World Forum for Harmonization of Vehicle Regulations**Working Party on Passive Safety****Sixty-first session**

Regulation No. 129 (Enhanced Child Restraint Systems)**Proposal for the 03 series of amendments as Phase 3 of
Regulation No. 129 (Enhanced Child Restraint Systems)****Submitted by the expert from France***

Figure 4

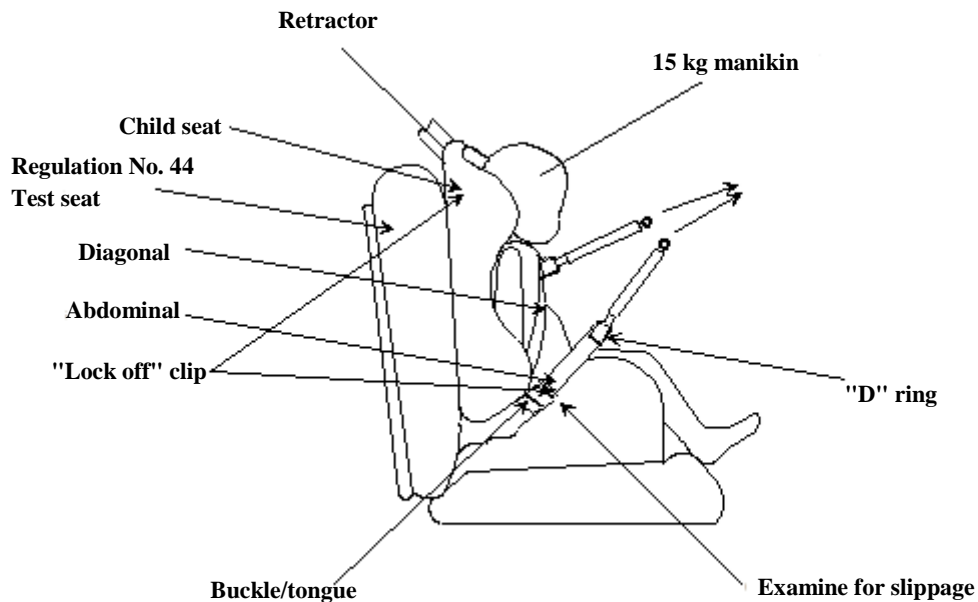
7.2.9.1. Class A devices

The child restraint and the largest manikin for which the child restraint is intended shall be set up as shown in Figure 4 below. The webbing used shall be as specified in Annex 23 to this Regulation. The lock-off shall be fully applied and a mark made on the belt where the belt enters the lock-off. The force gauges shall be attached to the belt via a D ring, and a force equal to twice (± 5 per cent) the mass of the heaviest dummy of group I shall be applied for at least one second. The lower position shall be used for lock-offs in position A and the upper position for lock-offs in position B. The force shall be applied for a further 9 times. A further mark shall be made on the belt where it enters the lock-off and the distance between the two marks shall be measured. During this test, the retractor shall be unlocked.

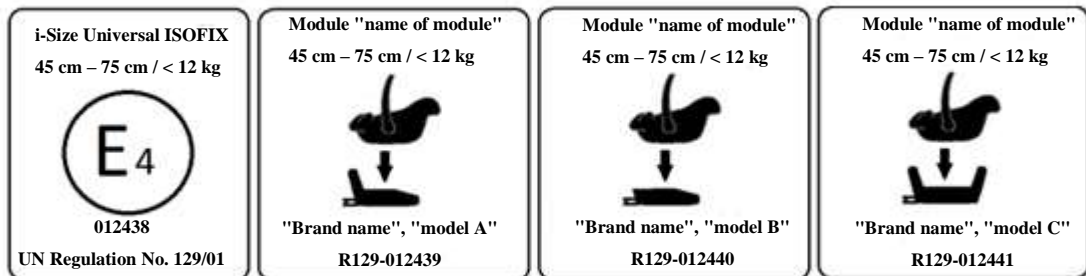
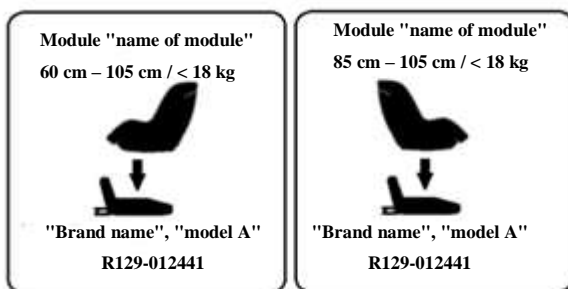
1. Arrangements of the approval mark
...
2. Arrangements of the approval mark in combination with a module mark
...
- 2.1. Arrangements of the module mark in combination with an approval mark
- 2.1.1. **Where a module is approved for use with more than one base, the individual base and module combinations are to be indicated on the module in separate module marks and each shall bear their applicable size ranges.**

An Enhanced Child Restraint System that bears an approval mark for the stand-alone configuration of use and a module mark for the use on three different bases thus carries the following arrangement of approval and module marks:

An Enhanced Child Restraint System bearing the above marks is capable of being used with a vehicle belt for the 45 cm - 75 cm size range and mass limit of 12 kg; it is approved under the number 001440.

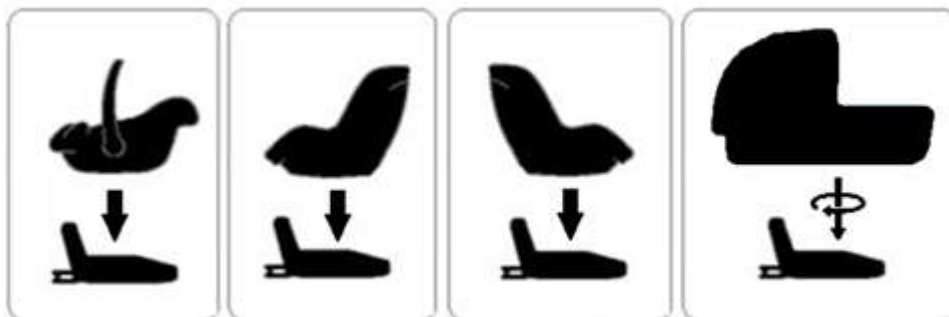
- 2.1.2. Where a module requires conversion of the product in order to transform from one transport configuration to the other, this shall be indicated in separate module marks, each bearing their applicable size ranges.

The Enhanced Child Restraint System bearing the above marks is capable of being used in a rearward facing configuration with the base "brand name & model A", for the 60 cm - 105 cm size range and with a mass limit of 18 kg; approved according to Regulation No. 129 under the number 012441.

The Enhanced Child Restraint System bearing the above marks is also capable of being used in a forward facing configuration with the base "brand name and model A", for the 85 cm - 105 cm size range and with a mass limit of 18 kg; approved according to Regulation No. 129 under the same number 012441.

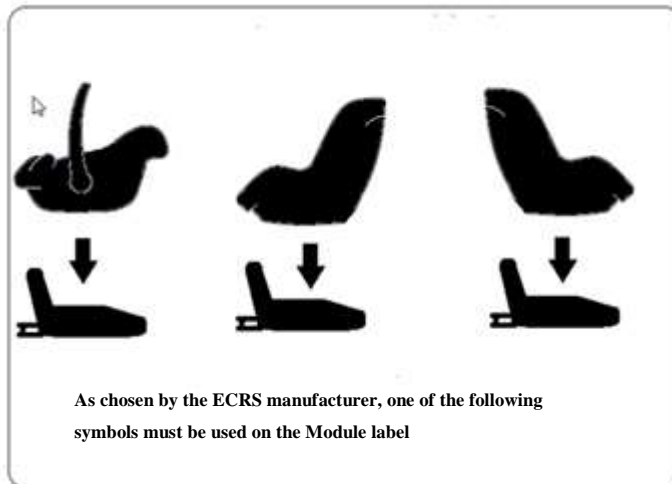
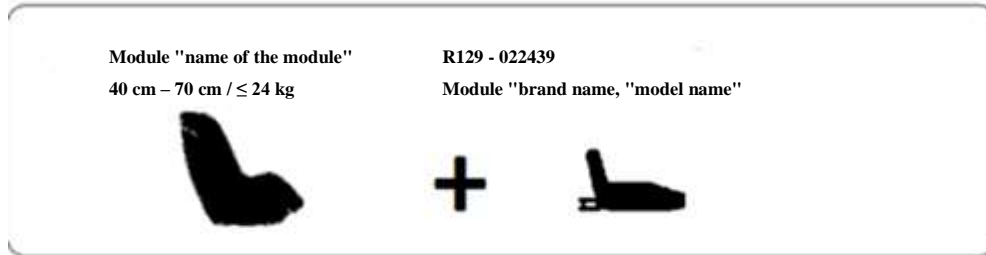
At the choice of the ECRS manufacturer, one of the following symbols must be used on the module mark.

2.2 Examples of the symbols to be used on the module mark are given in the figures below.

The Enhanced Child Restraint System module bearing the above module mark capable of being used for the 40 cm – 70 cm size range and mass limit of 24 kg; it is approved under the number 022439 to be used in combination with device approved according to Regulation No. 129 under the same number 022439. The approval number indicates that the approval was granted in accordance with the requirements of the Regulation concerning the approval of Enhanced Child Restraint Systems used on board of motor vehicles as amended by the 02 series of amendments."

Figure 1
Procedure type 1

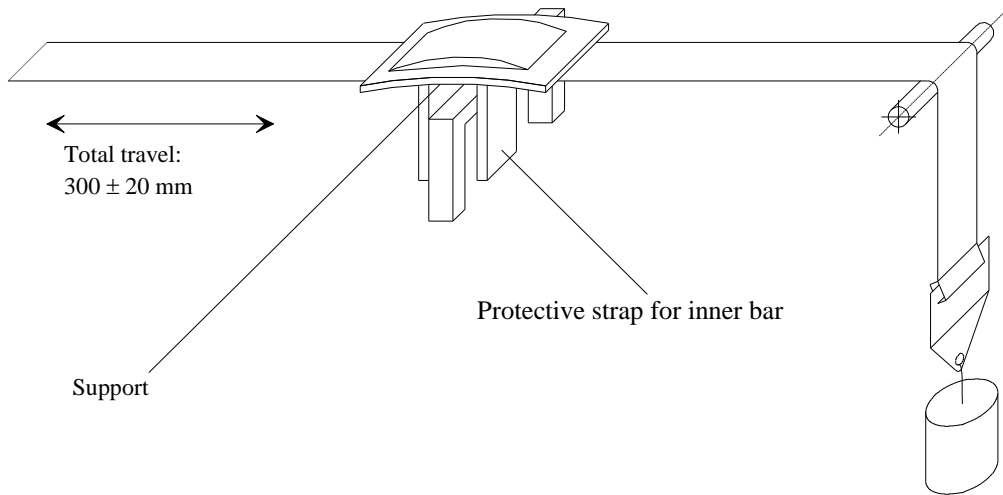
Annex 5, Figures 1 and 2, amend to read:

F = 10 ± 0.1 N, can be increased up to F = 60 ± 0.5 N

Figure 2
Procedure type 2
 Following two examples of test set up

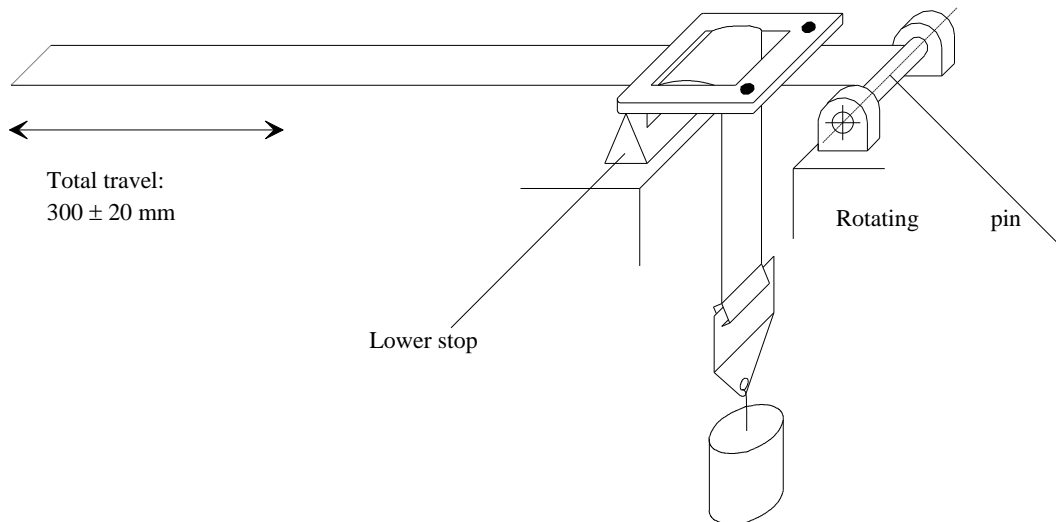
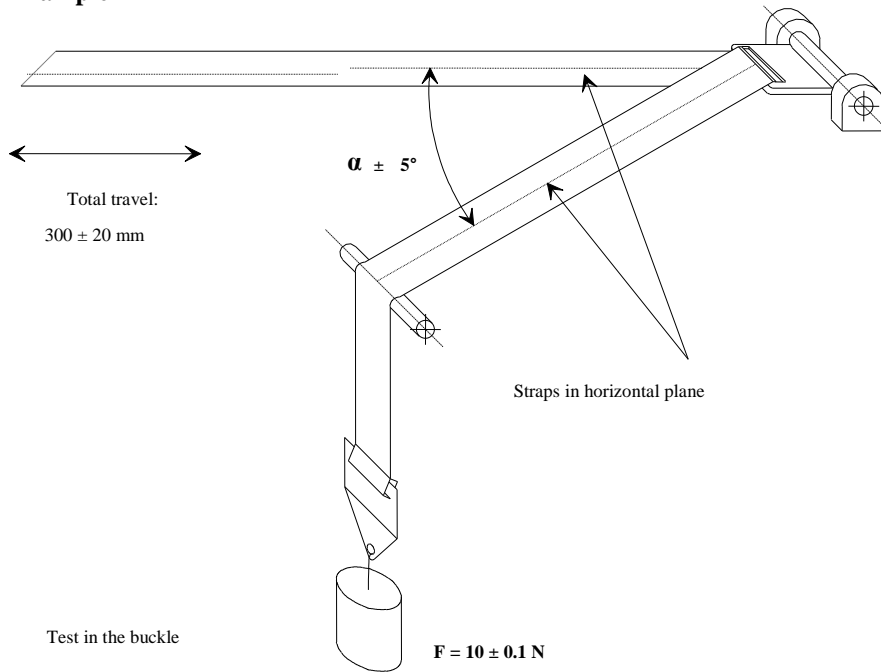
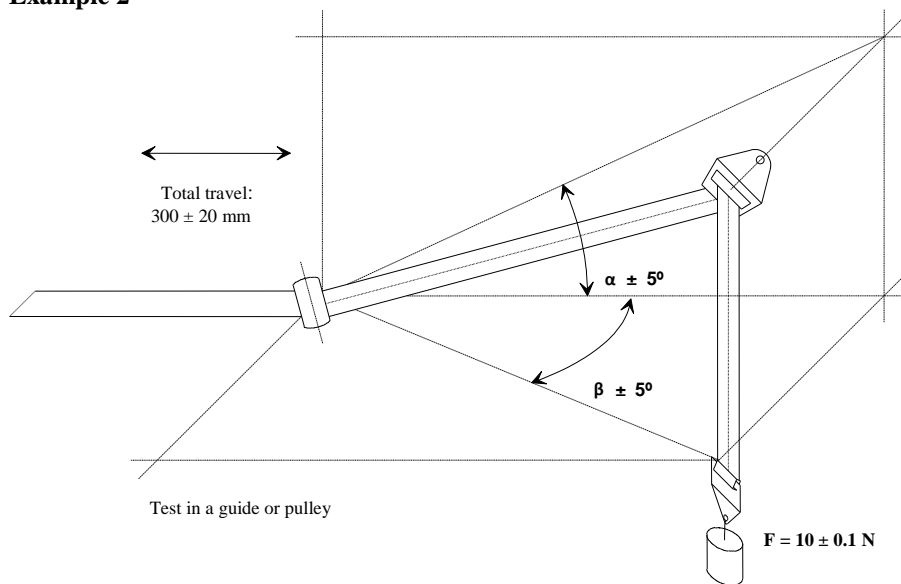
F = 10 ± 0.1 N, can be increased up to F = 60 ± 0.5 N

Where α and β reproduce the angles as in the real installation (in three dimensions)
 ..."
